# CITY OF BLOOMINGTON

December 21, 2017 @ 5:30 p.m.  
COUNCIL CHAMBERS #115  
CITY HALL

**BLOOMINGTON BOARD OF ZONING APPEALS**  
**STAFF REPORT**  
Location: 722 W 2<sup>nd</sup> St.

**CASE #: UV/V-30-17**  
**DATE: December 21, 2017**

#### **#9. Non-compliant Landscape Plan**

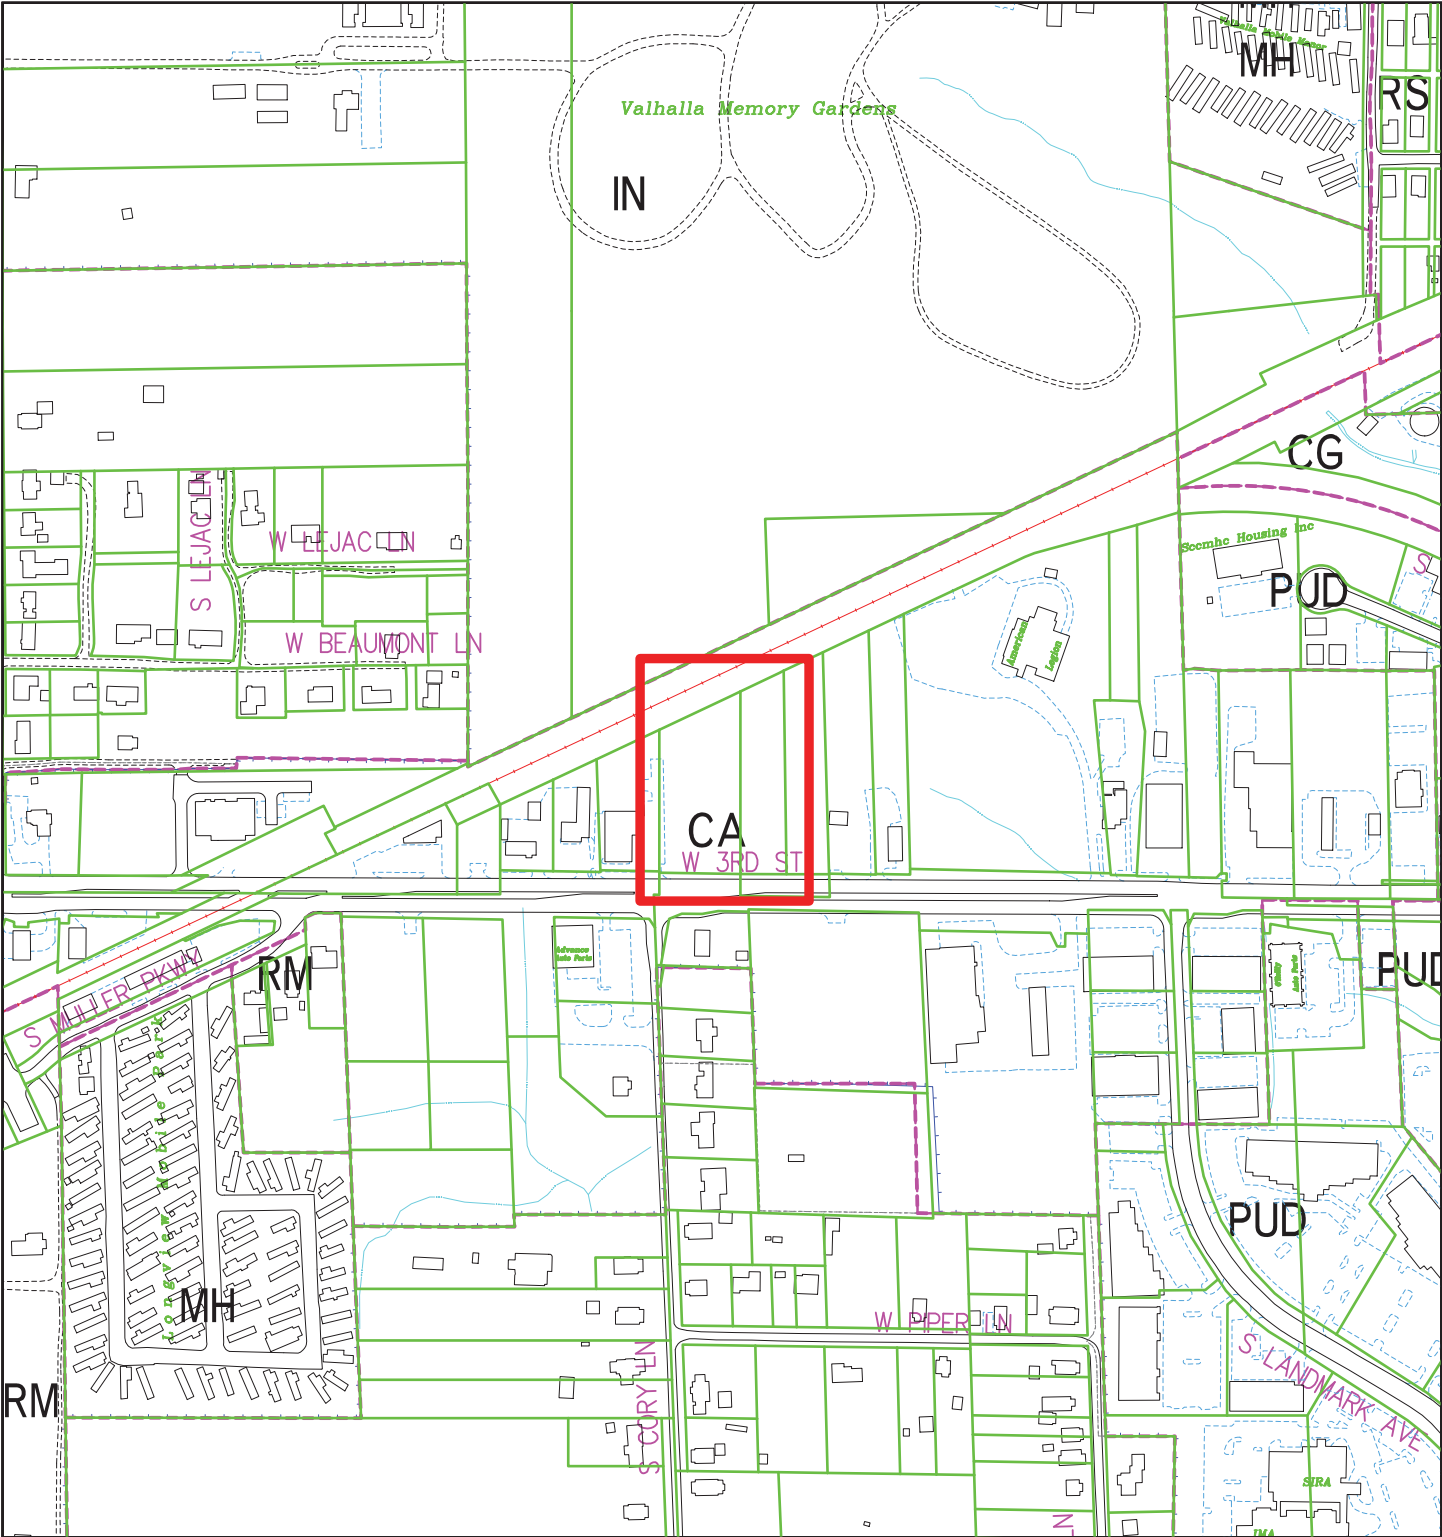
The Landscape Plan currently has many problems and is not in compliance with the landscape standards in 20.05.052. The Petitioner has not requested a variance from this Section, so the EC expects the Landscape Plan will eventually be brought into compliance.

The EC is disappointed with the small number of native plants on the plant list. As the Petitioner revises the plan, the EC recommends that they incorporate more

native plants and steer away from those that are not. The hope is the new plants will mimic the native setting because using native plants provides food and habitat for birds, butterflies, and other beneficial insects, and promotes biodiversity in the city. Furthermore, native plants do not require chemical fertilizers or pesticides and are water efficient once established.

Additionally, many of the trees adjacent to the construction zone will not live into the future after having their root zones damaged by construction, such as the ones at the back of the property. The Landscape Plan should take this into account by removing the trees closest to the construction zone and replanting when construction is complete, or keeping them but not counting them toward their required plant numbers.

1162 DEMOLITION PLAN  
designed by: JBT  
drawn by: JBT  
check by: JBT  
sheet no.: C201  
Project no.: 401565

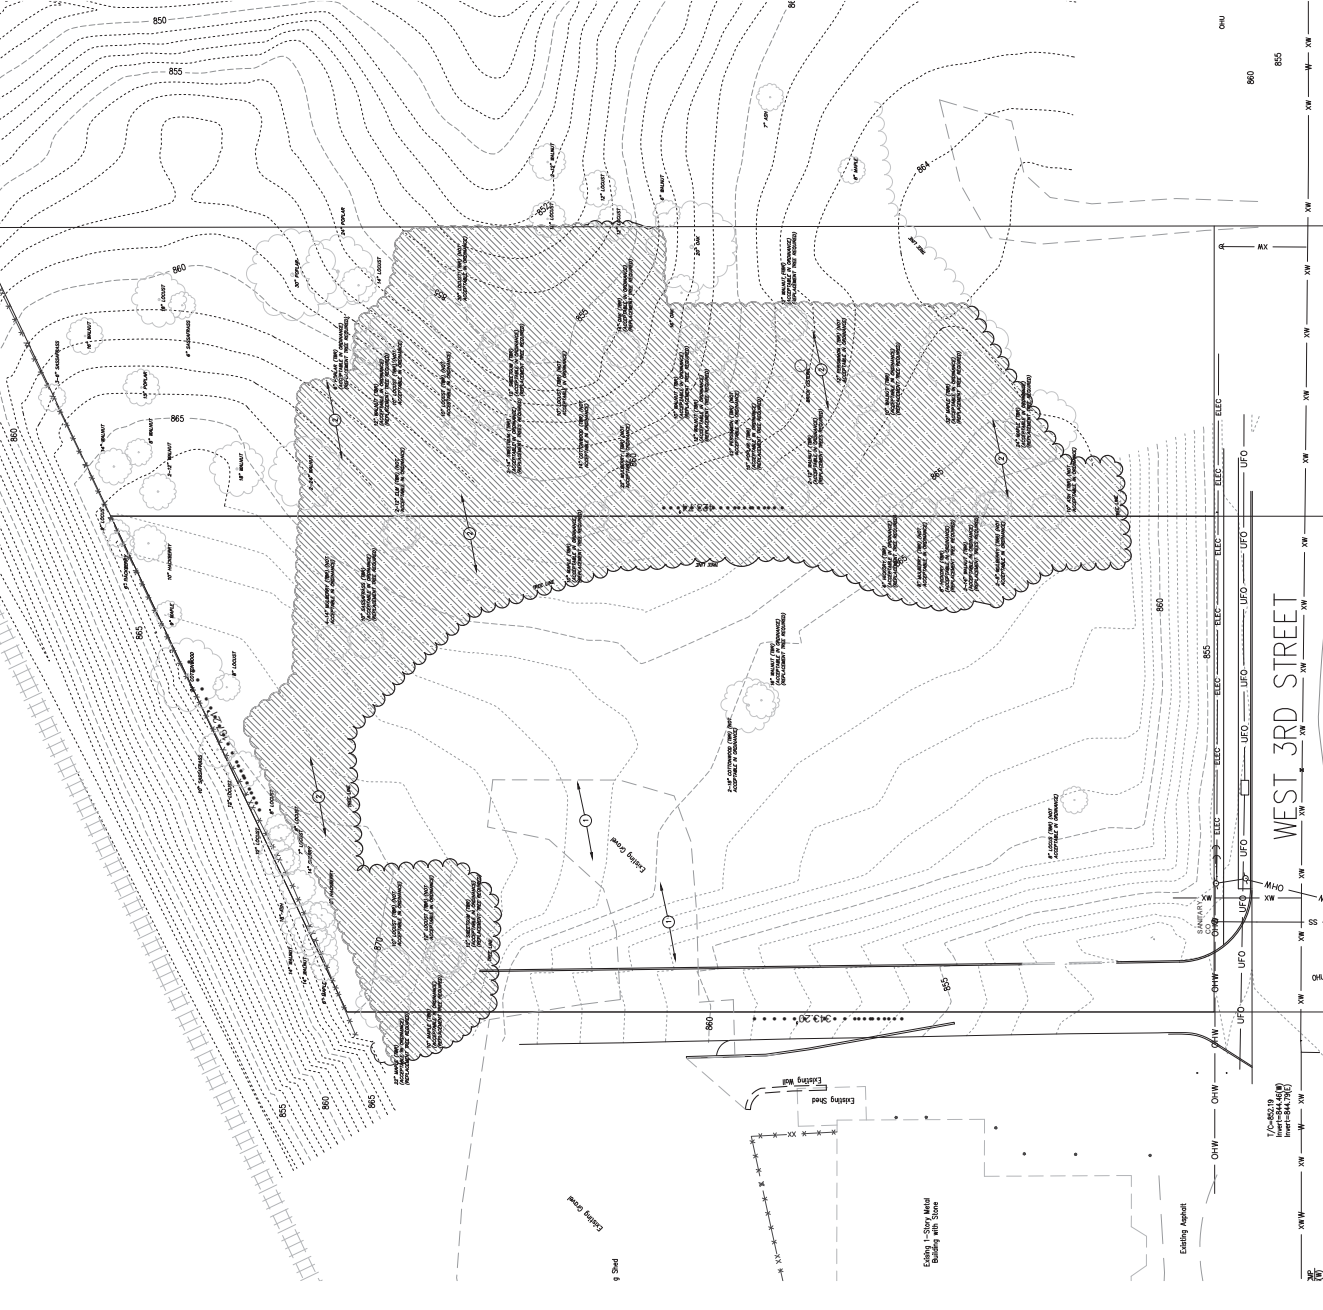
The Demolition Plan depicts the wooded area planned for removal and has identified the trees within that area. No other vegetation within the floor and middle stories of the wooded area have been identified. The purpose of this exercise was to identify and count the trees that the city would find acceptable, and to identify and count those that it would not. Unacceptable trees are invasive or trees with poor characteristics such as weak wood. The Petitioner has offered to replant new trees in place of the number of acceptable trees, but not the others.

The problem is that the Demolition Plan shows trees to be removed that are misidentified. For example, *Tilia Americana*, commonly called Basswood or American Linden, was labeled as mulberry. It doesn’t specify if it’s a red or white mulberry. Red mulberries are native trees that are acceptable, while white mulberries, *morus alba*, are invasive and not allowed. Additionally, persimmon and cottonwood trees were identified as bad trees, but are not found on the lists of invasive or trees with poor characteristics and would be acceptable, because they are native to this area. The trouble with these mistakes is that it skews the number of trees that the Petitioner has offered to replace; that number is actually higher.
